# In support of response to comment #52

Leon Bruckman (Huawei)

# Comment #52 – From Adee Ran

# 400GBASE-ZR PCS functional block diagram

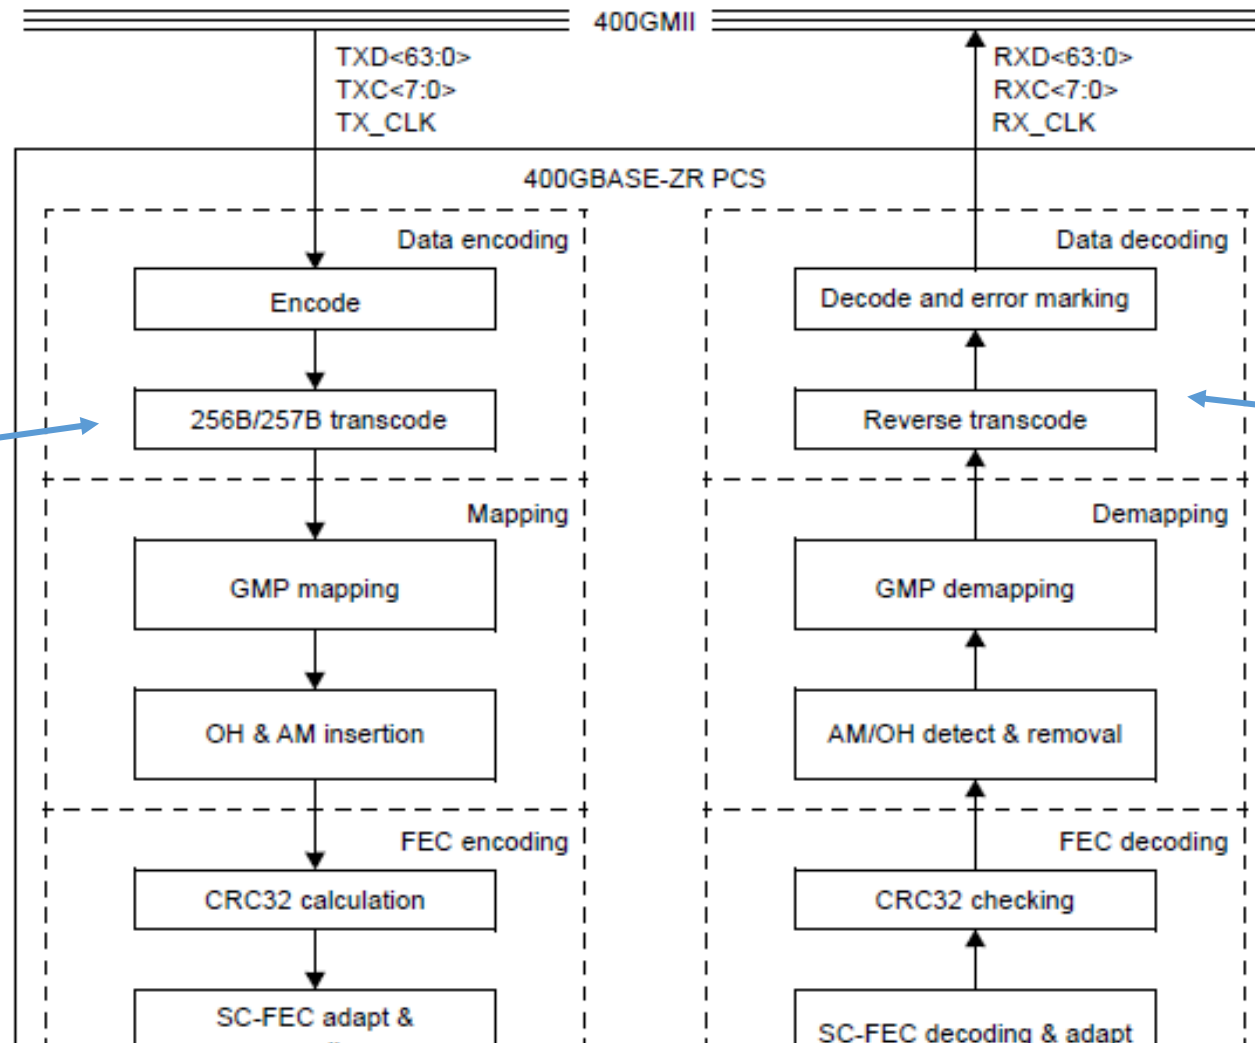
No idle removal to make room for AMs

No idle insertion to account for AMs

# 400ZR – 400GBASE-ZR Interoperability: Option 1

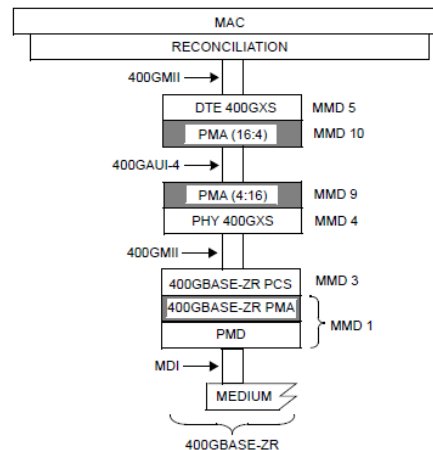
- 400ZR signal rate: 401.542892 Gb/s, 400GBASE-ZR signal rate: 401.5625 Gb/s
- 400ZR side 400GAUI-8 PCS to PHY 400GXS transmit clock generation:
  - Recover clock from GMP payload (401.542892 Gb/s)
  - Multiply it by  $544/514 \times 163840/163832$  to get the 425 Gb/s 400GAUI-8 rate
  - If the peer is a 400GBASE-ZR the result will be +49 ppm off
- In the 400GBASE-ZR side (receiving a signal from a 400ZR interface) there is no clock recovery at the receive side
  - If a 400GMII extender is used, then the 400GAUI-4 rate may be off by -49 ppm
